ADDENDUM NO. 3
TO THE
CONTRACT DOCUMENTS
FOR

RFP#2325-05 NORTH ALBANY PARK RESTROOM

January 17, 2024

RFP 2325-05 Engineer's Drawings - Bathrooms - Corrected

A1.0

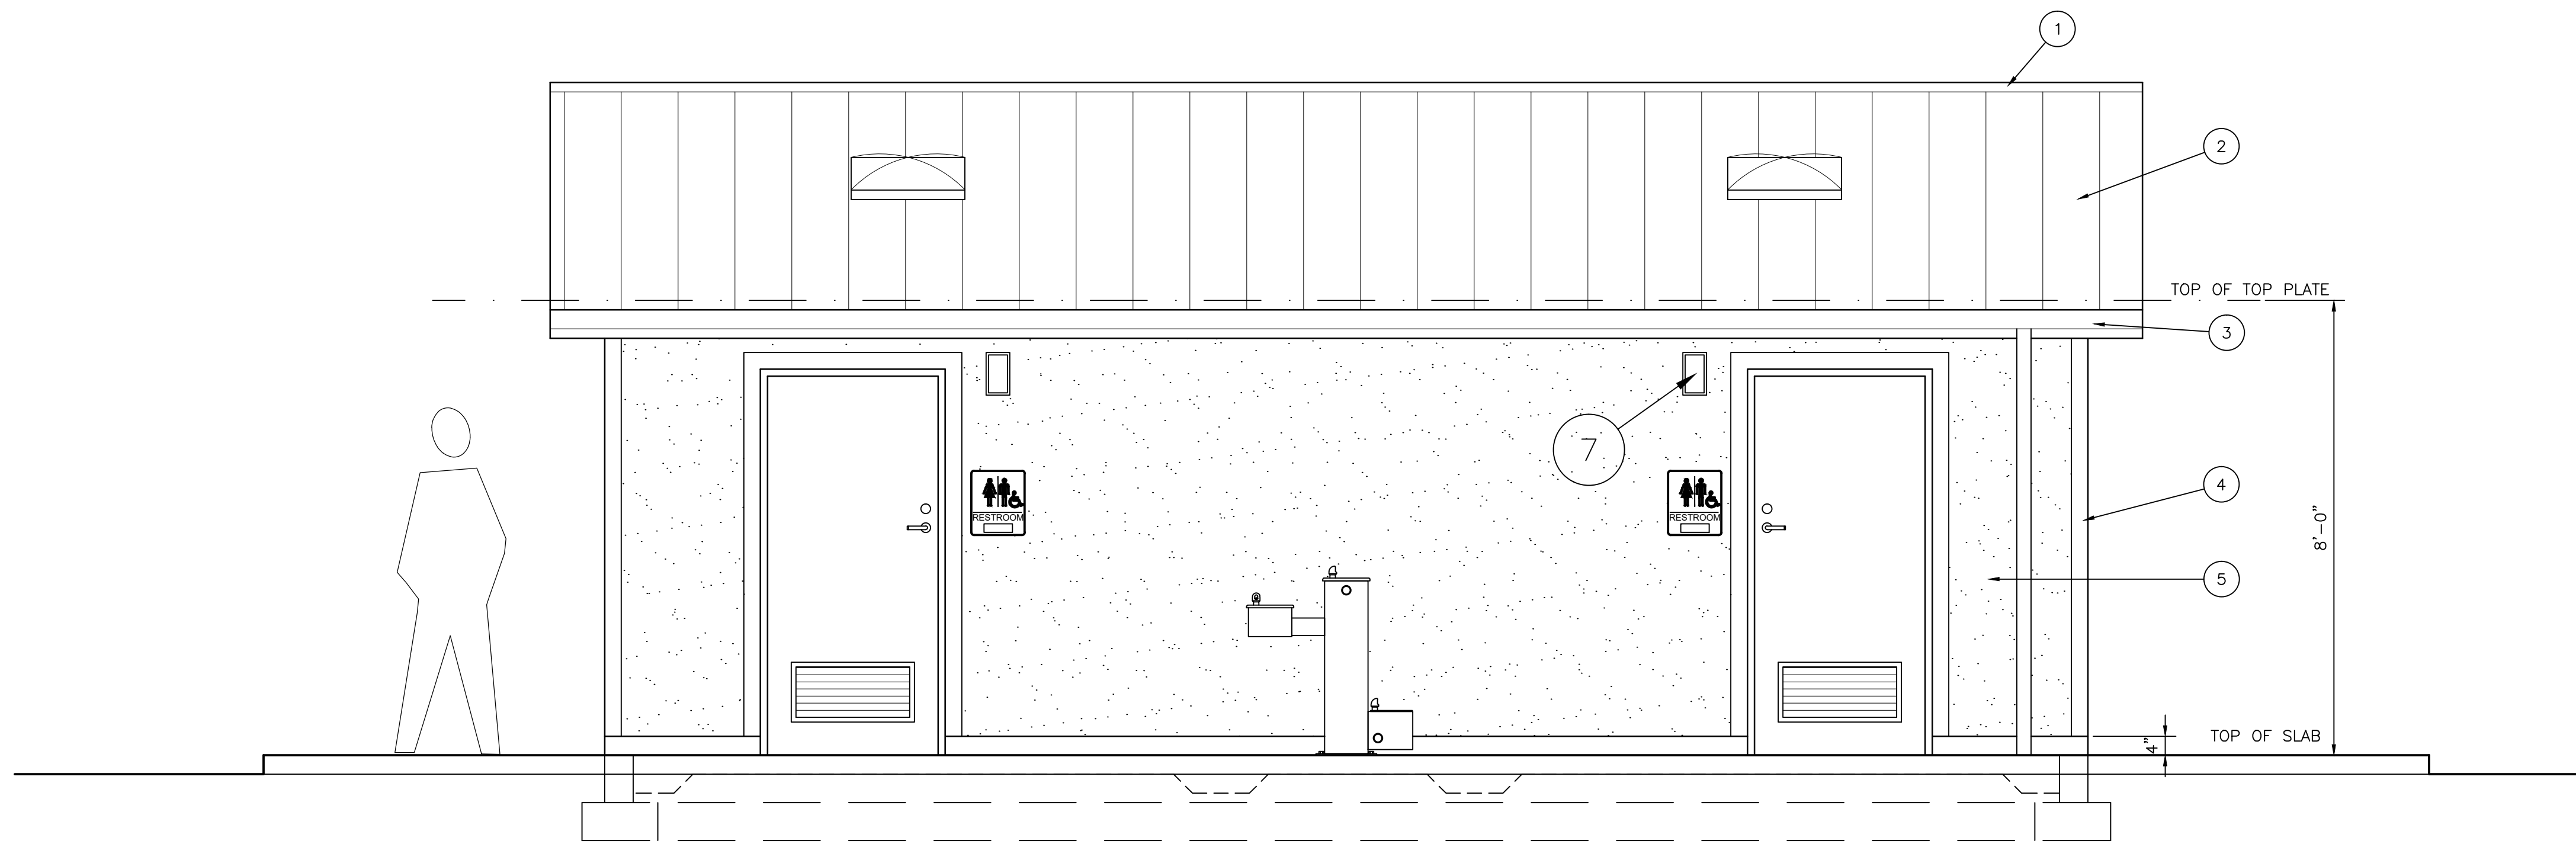
- A1.0 & A1.1 titles on the index are swapped
- missing sheet A6.0

Will be updated and replace existing document.
